CERTIFICATE OF APPROPRIATENESS

Property: 534 Cortlandt Street, Lot 22, Block 288, Houston Heights Subdivision. The property includes a historic 1,330 square foot, one-story wood frame single family residence and detached garage situated on a 6,600 square foot (50' x 132') interior lot.

Proposal: Alteration – Construct a two-story rear addition to one-story contributing house
Addition:

HAHC Action: Approved

WEST ELEVATION – FRONT FACING CORTLANDT STREET

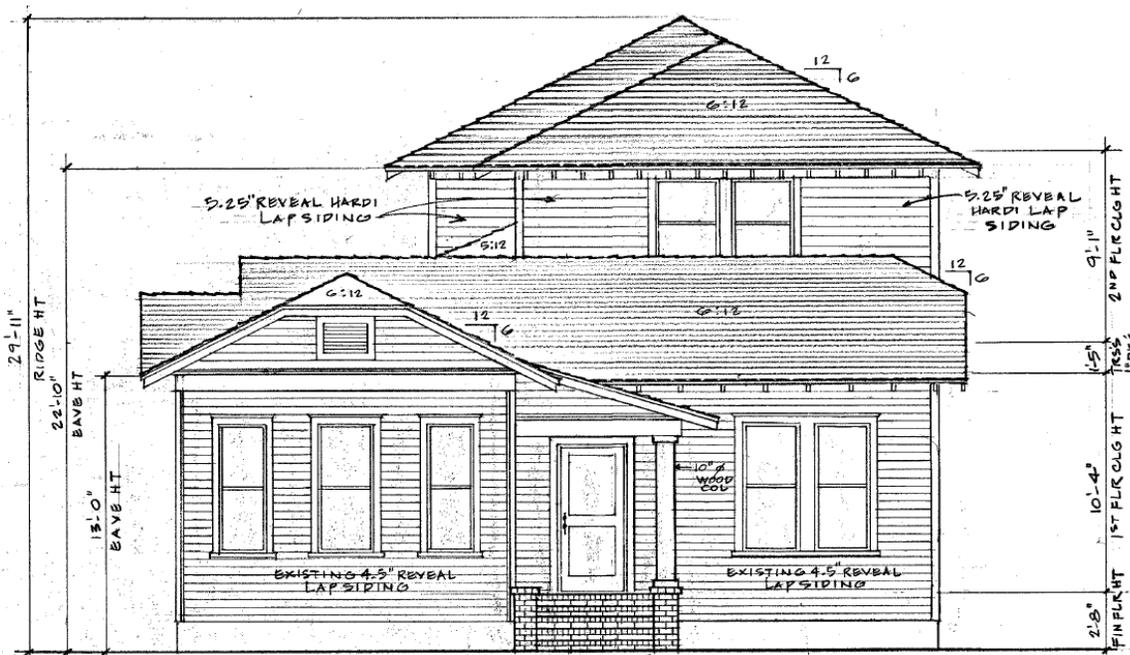
Proposed steps to be concrete,
not brick as drawn
